TO: HISTORIC PRESERVATION BOARD

RE: CERTIFICATE OF APPROPRIATENESS 2023-COA-04

ROOF REPLACEMENT AND MODIFICATION AT 421 EAST LEMON AVENUE (AK 1631131)

PROPOSED PROJECT:

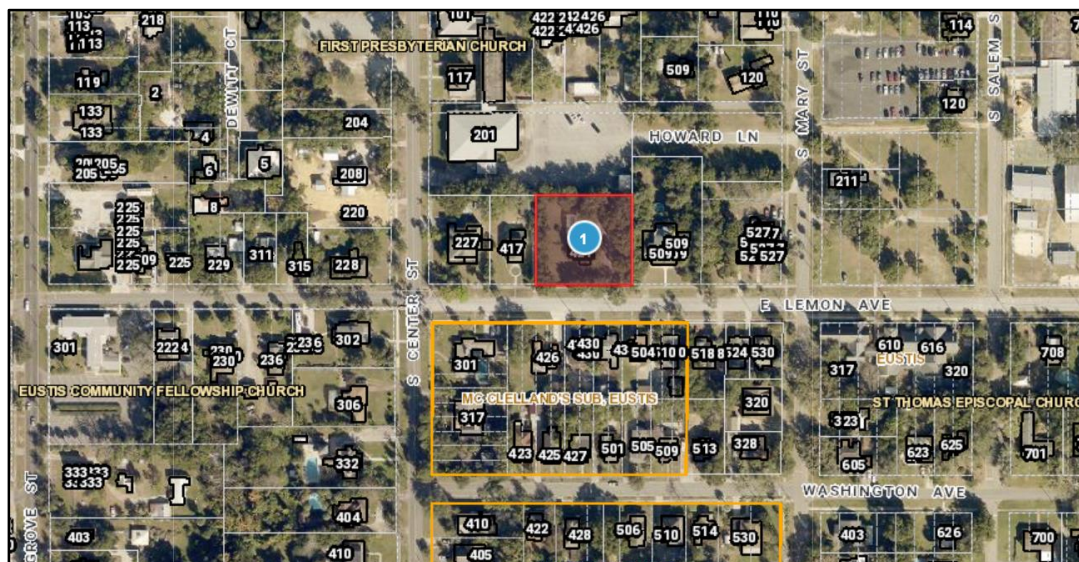
The proposed re-roof for a metal roof in lieu of shingles is not consistent with the surrounding properties nor the historic time period of the home. Per the Florida Master Site File for this property, the roof was surfaced with composition shingle. The home was originally built in 1920 and is identified as the Colonial Revival architectural style.

The proposed re-roof for a metal roof in lieu of shingles is not consistent with the surrounding properties nor the historic time period of the home. Per the Florida Master Site File for this property, the roof was surfaced with composition shingle. The home was originally built in 1920 and is identified as the Colonial Revival architectural style.

This local landmark, 421 East Lemon Avenue, is classified as the Colonial Revival architectural style. The proposed metal roof replacement is not consistent with the historical roofs that were generally with shingles.

Per the master site file for this property, the historical context is the “boom times”. The home was built in 1920 with a colonial revival style, wood frame. As stated above, metal roofs were not generally an element in the colonial revival architectural style, but rather shingle roofs were common, which is what is currently on the house at this time.

Based on the analysis above, the criteria for evaluation provided in this memorandum, and the site plan for the re-roof, staff recommends denial of the request.
